MIL-R 83536/13
AMENDMENT 1
15 December 1995

MILITARY SPECIFICATION SHEET

RELAYS, ELECTROMAGNETIC, ESTABLISHED RELIABILITY, DPDT
LOW LEVEL TO 10 AMPERES, MAGNETIC LATCH HERMETICALLY SEALED
ALL WELDED, TRANSIENT SUPPRESSED DC COIL

This amendment forms a part of MIL-R-83536/13, dated 27 March 1992, and is approved for use by all Departments and Agencies of the Department of Defense

CIRCUIT DIAGRAM (TRACK MOUNT)
(OPTIONAL INTERNAL
DIODE CONFIGURATION)

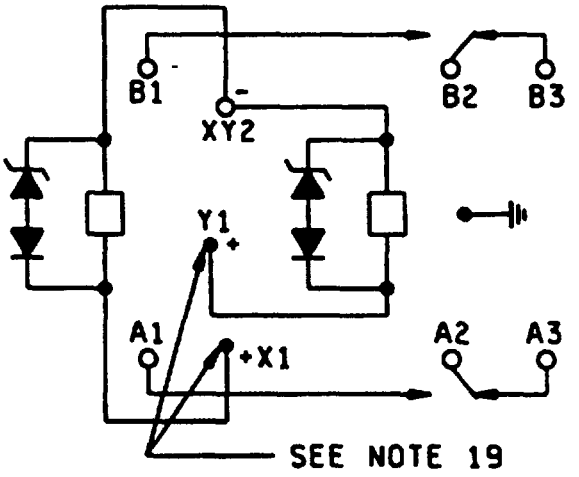
FIGURE 2, add the following circuit diagram

SEE NOTES 4, 5, AND 6
